DESCRIPTIVE REPORT

Registry Number: F00574

HYDROGRAPHIC TITLE SHEET

Project S-A936-TJ-09
 Gulf of Maine, ME
3 NM SE of York Harbor Entrance
 Scale 1:10,000
 October 1–5, 2009
NOAA Ship *Thomas Jefferson*

1.1) 1623/32_20ft_Rock**DANGER TO NAVIGATION****Survey Summary**

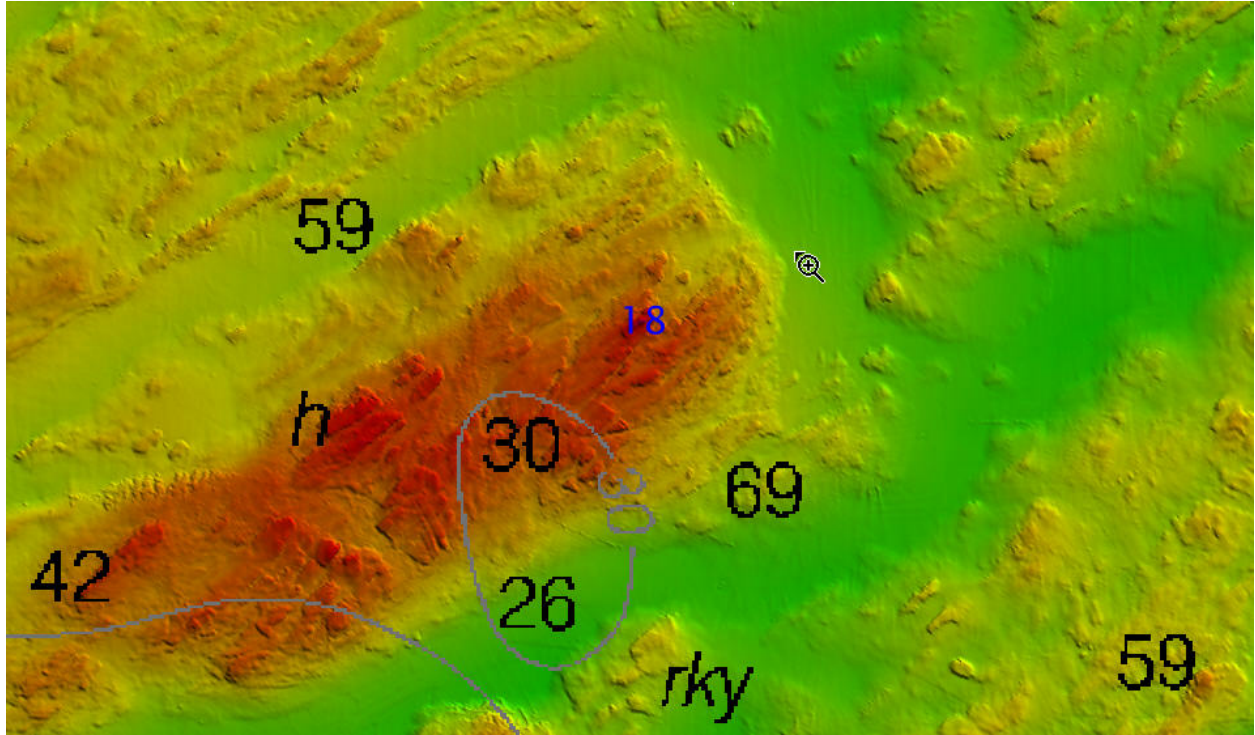
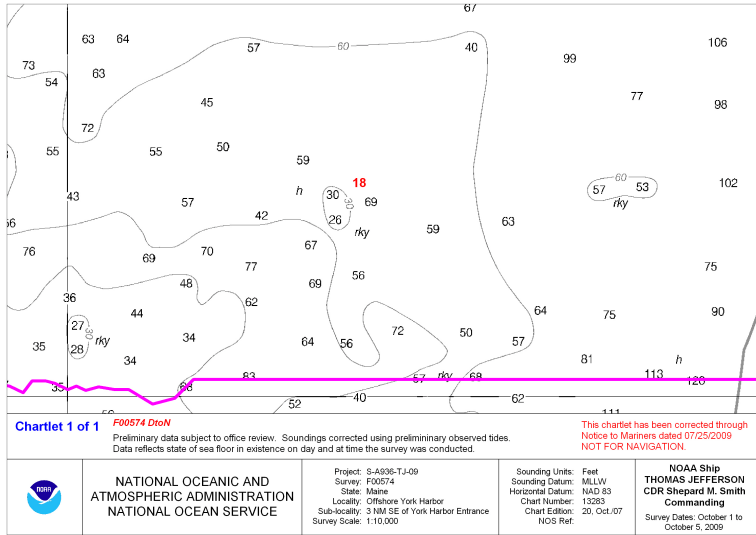
Concur with clarification. The Rk is charted as a result of a DtoN report submitted by this survey corrected with preliminary water levels. Final tidal correction yields 20ft Rk. Delete 18ft rock. Add 20 ft rock.

1.2) 1693/312_Rocky_Area

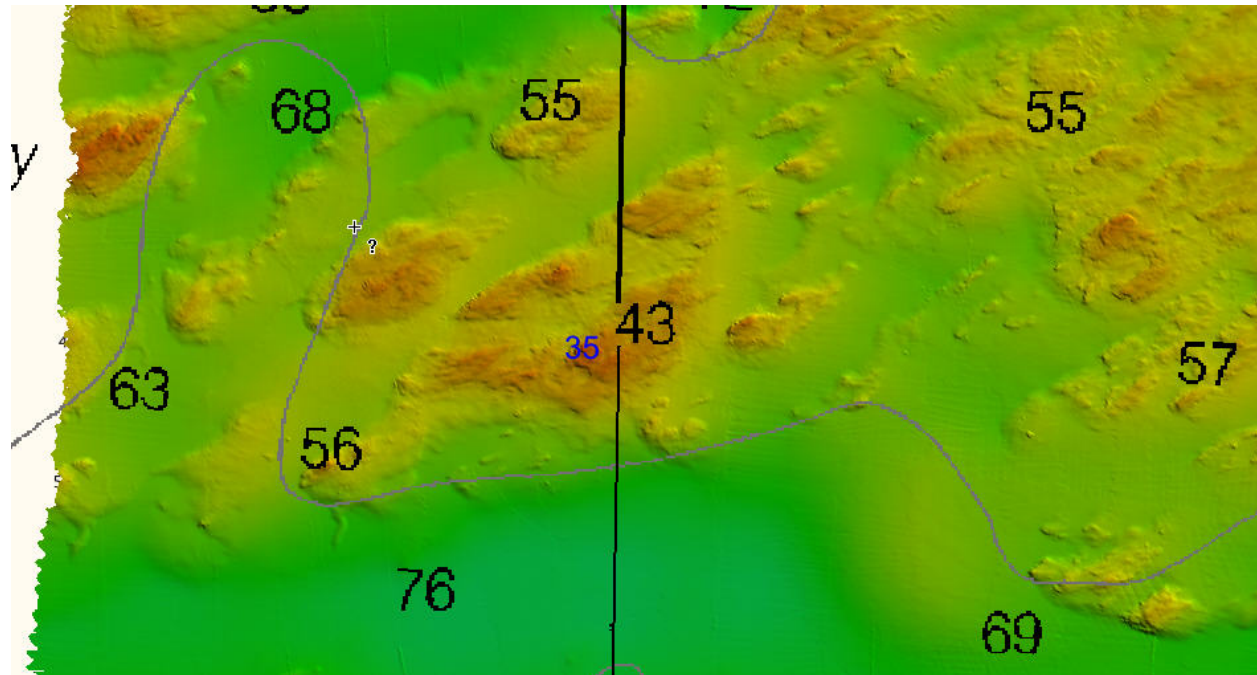
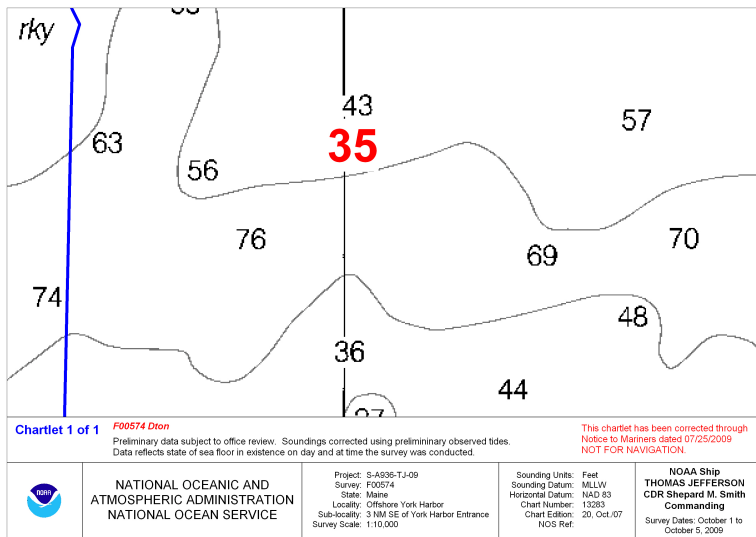
Do not concur. Feature is the least depth of a rocky area. Recommend feature be represented as a sounding within a rocky seabed area, included in the H-Cell deliverable. Recommend to delete 35 Rk from the chart.

1.1) 430/132 16ft Rk

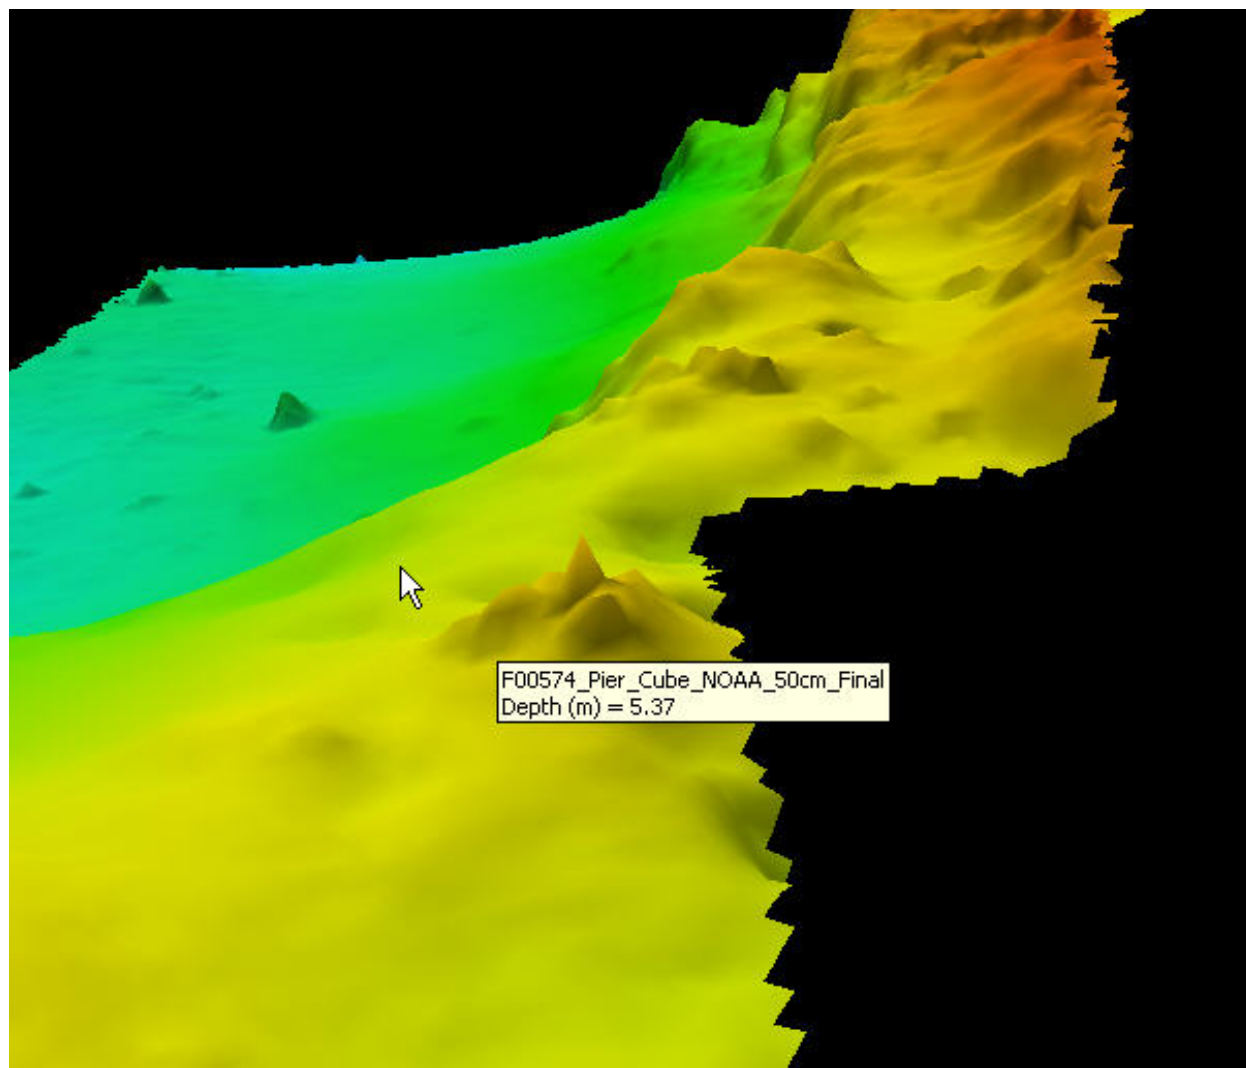
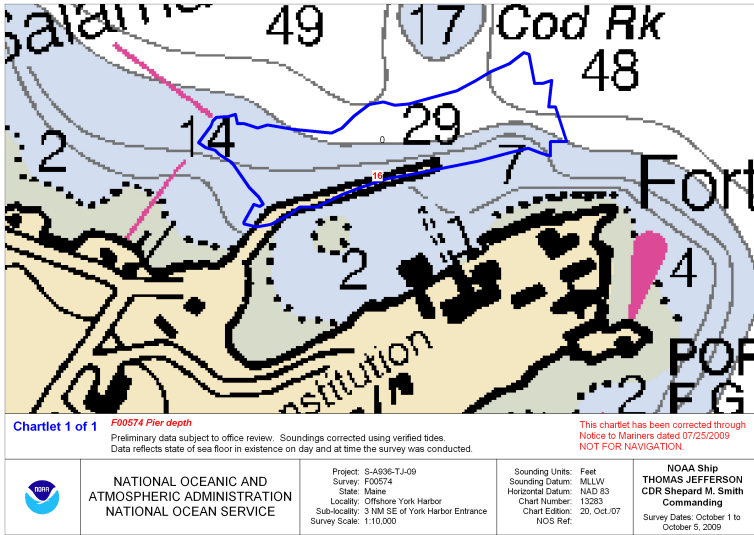
Do not concur. Obstruction was identified as a rock in a dive report submitted in Appendix V of the DR. Do not chart rock, recommend to include depth in raster chart legend.

1.2) 534/95 14ft Rk

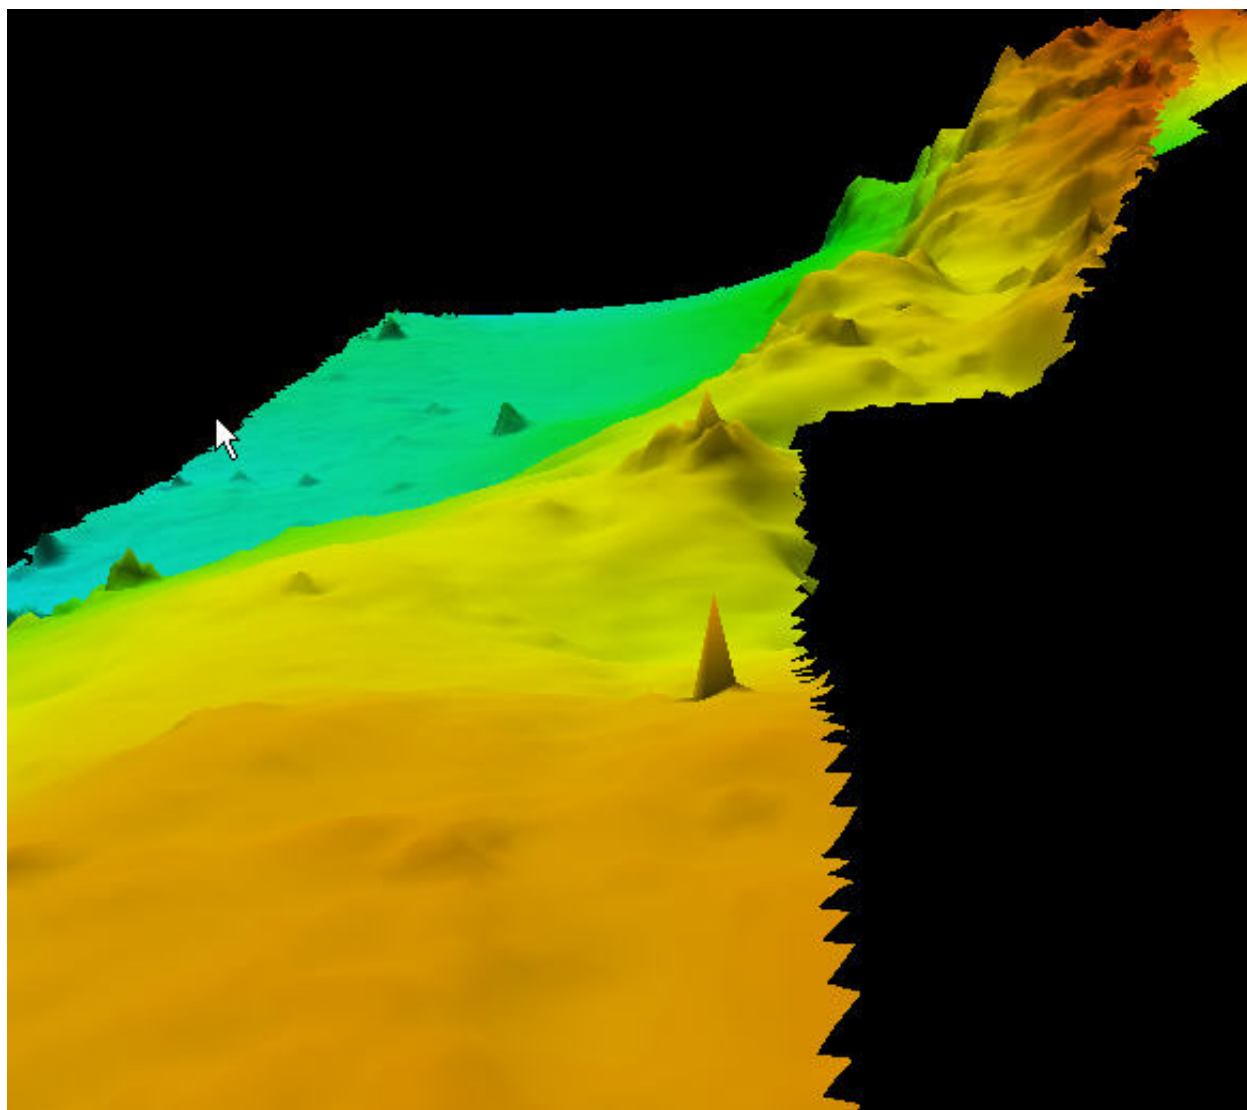
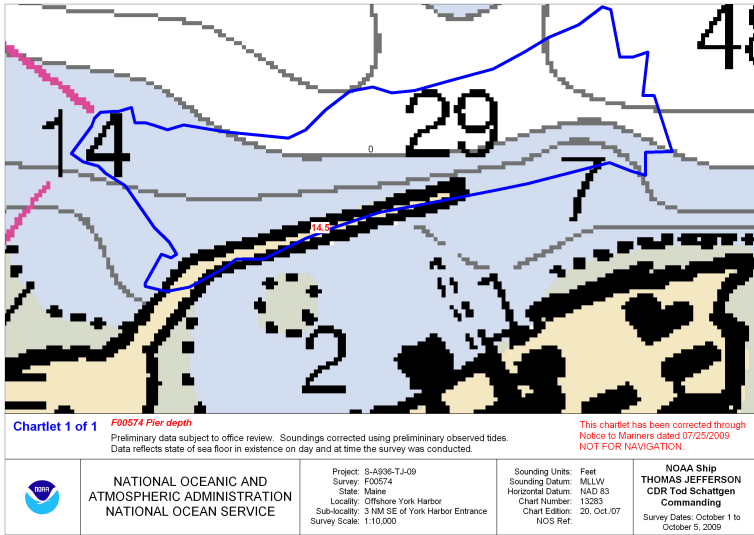
Do not concur. Obstruction was identified as a rock in a dive report submitted in Appendix V of the DR. Do not chart rock, recommend to include depth in raster chart legend.

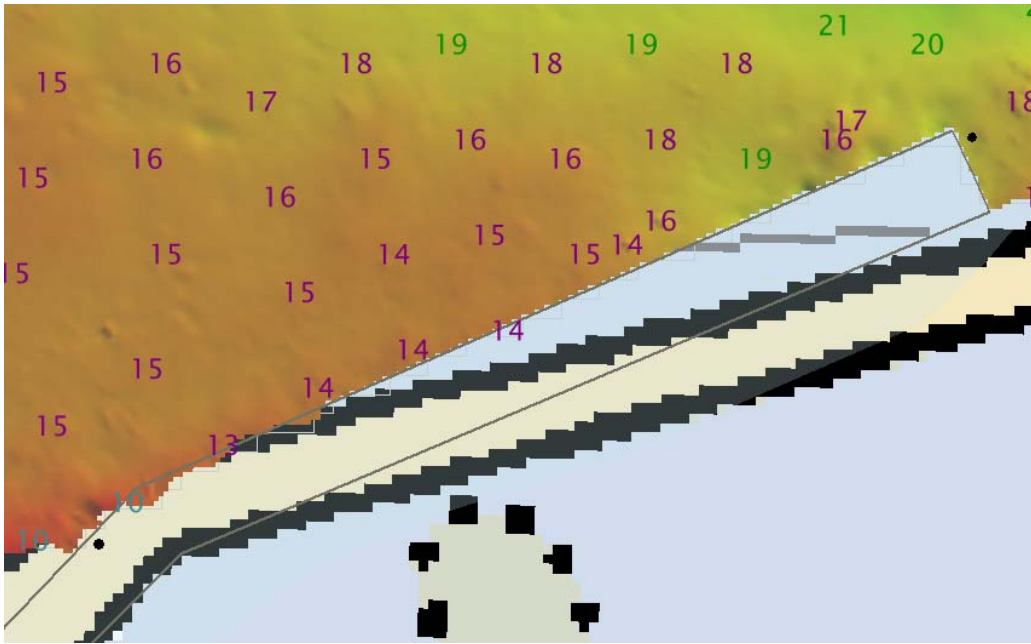
- a. The pier located at 43-04-19.1586N, 70-42-42.3342W was digitized to the extent of bathymetry. Three centerline points for this new pier were provided in the attached UNH document, “As-built Control”, located in Appendix V. These points were acquired with a consumer-grade hand-held GPS unit and were of suspect accuracy. As such they were compared to the survey data acquired by NOAA Ship Thomas Jefferson. It was found that there was poor agreement between the centerline points provided by UNH and the Thomas Jefferson data. As such, the dimensions and orientation of the new NOAA/UNH pier were derived from the Thomas Jefferson multibeam sonar data which ensonified all the underwater structure of the pier. When completed, the new digitized pier will be home to the NOAA Ship Ferdinand R. Hassler. The 14 foot depths along the pier are critical for the Hassler, which has a draft of 15 feet. To read more on the Ferdinand Hassler, see the Seacoast Online article, “Technology shows local ocean maps outdated” in Appendix V.
